RS-01-022

February 15, 2001

Subject: Revision D to Request for Technical Specifications Changes for Dresden Nuclear Power Station, Units 2 and 3, LaSalle County Station, Units 1 and 2, and Quad Cities Nuclear Power Station, Units 1 and 2, to Implement Improved Standard Technical Specifications

Figure 3.1.7-1 (page 1 of 1)
Sodium Pentaborate Solution Volume/Concentration Requirements

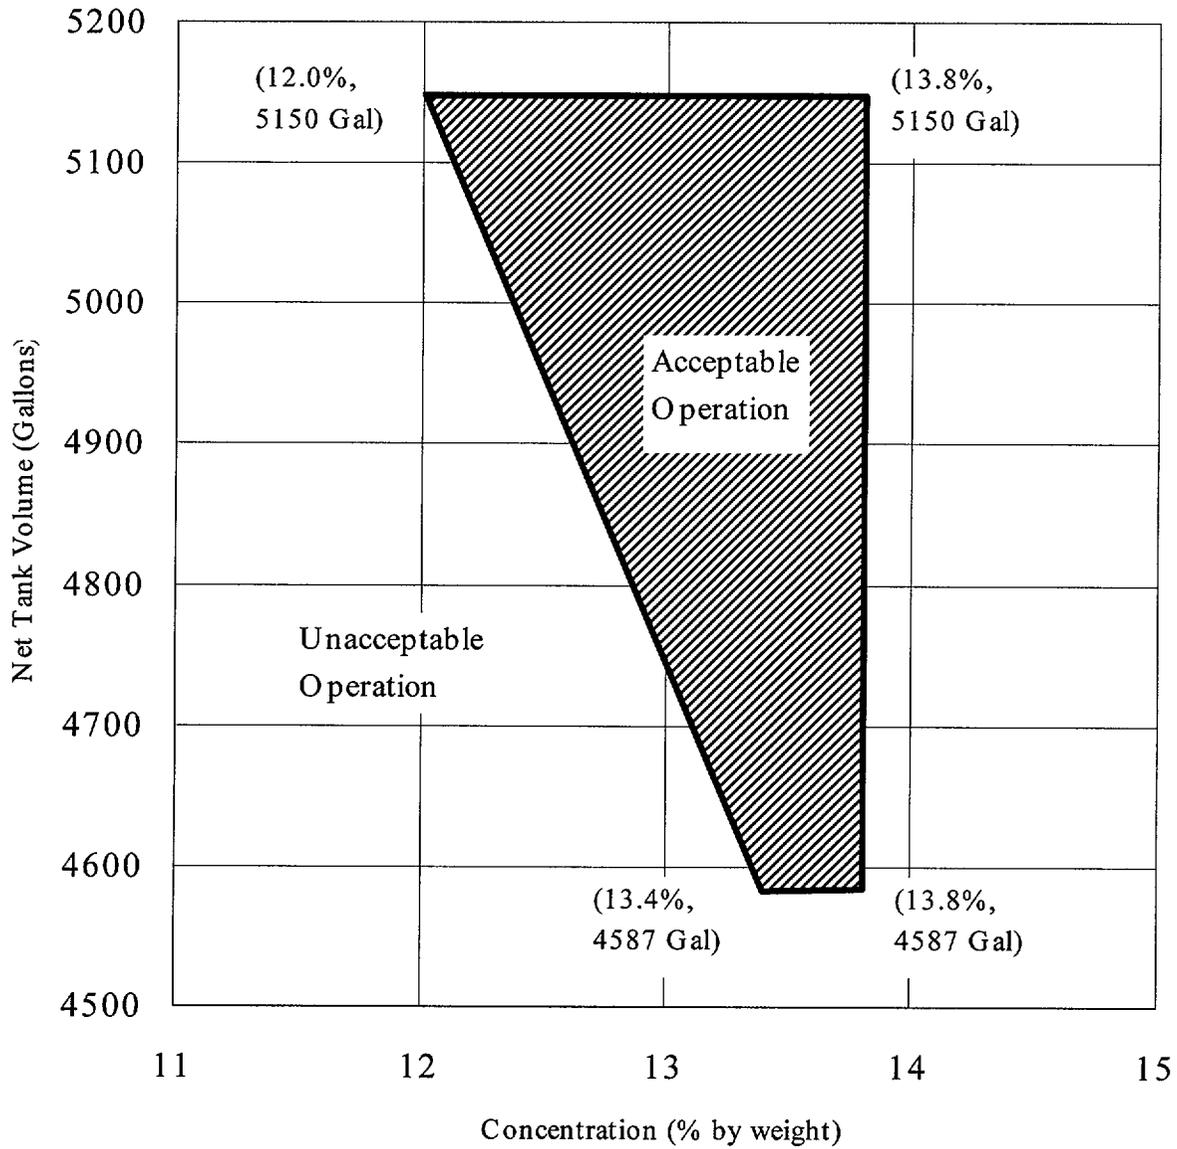
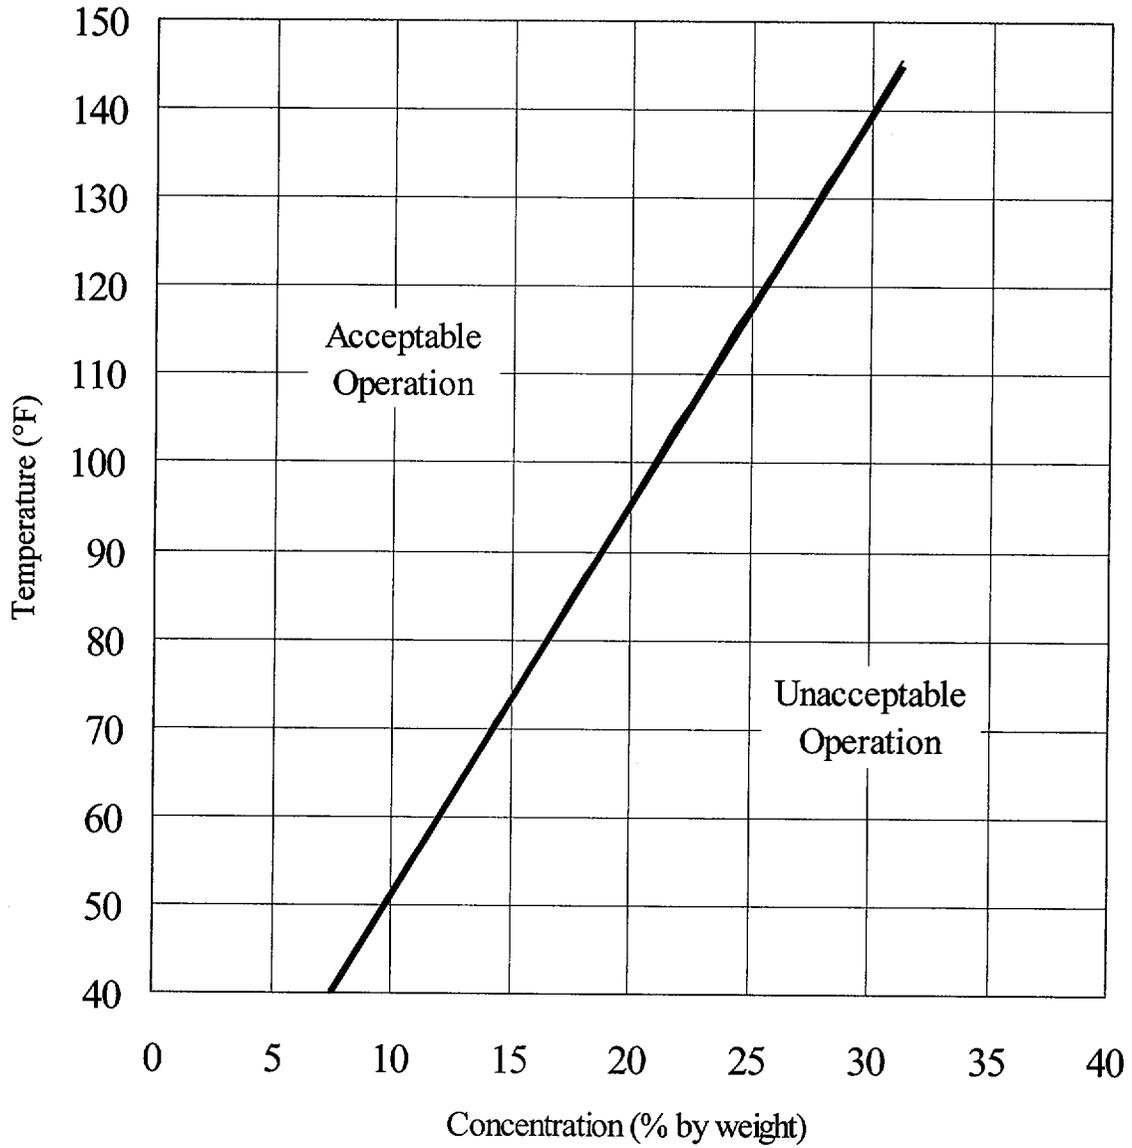
1. The word "boron" in the second Frequency in SR 3.1.7.5 has been changed to "sodium pentaborate" to be consistent with the words in the actual SR. This change affects the ISTS 3.1.7 markup page 3.1-21.
